**COLORADO DEPARTMENT OF TRANSPORTATION  
BRIDGE PROJECT STATUS SHEET**

Project #: BR 086A-037		Project code (SA#): 13380	
Combined with:		Project code (SA#):	
Hwy #: 86	Description: Bridge Replacement Widening / HBP Overlay		County: Douglas
Region #: 1	Consultant or CDOT Designer: CDOT		
R.E. William Scheuerman	Contractor: Lawrence Construction		
Bids opened: 3/14/02	Completion date:	Notice & Final settlement:	
6/14/02 110	Temp. file kev.: B-5

PROJECT NO. BR 086A-037

CMO#1, Revised 06/17/02,  
MMS, Wilson & Company

### Detour Typical Section

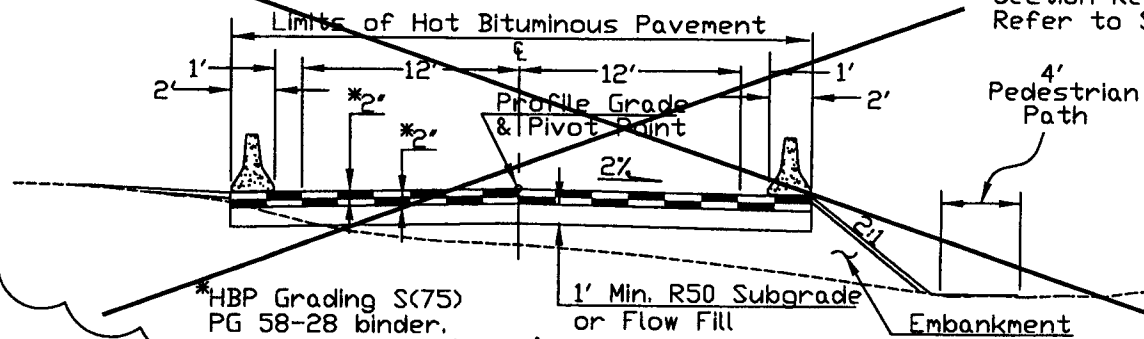
Detour Typical Section Revised,  
Refer to Sht. 5a

## Detour Typical Section – Bridge Construction One Way Traffic

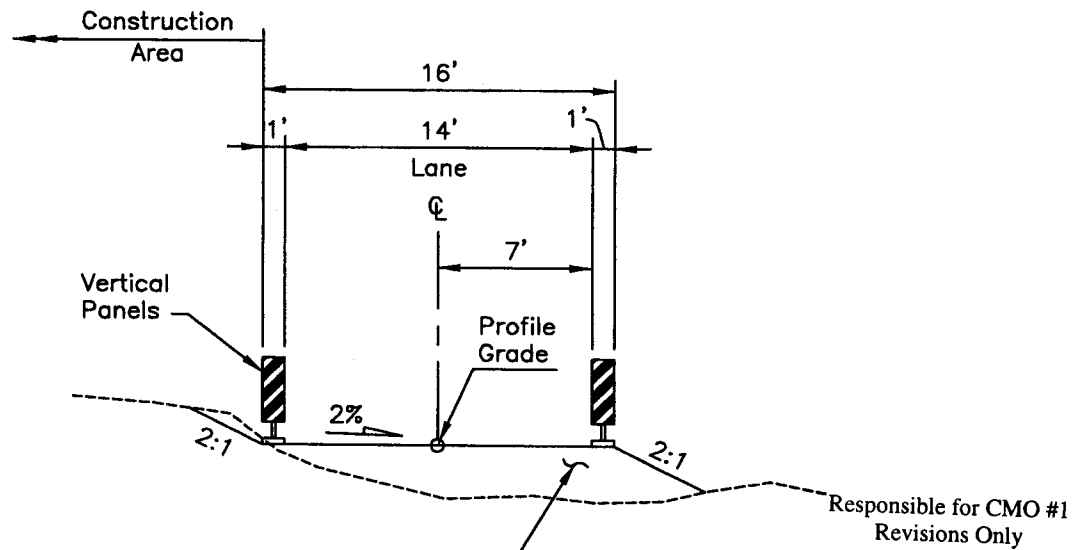
CMO#1, Added new sheet 5a, with new detour typical sections – 06/17/02, MMS, Wilson & Company

Embankment sealed with Magnesium Chloride. Magnesium Chloride will not be paid for separately, but shall be included in the price of the work.
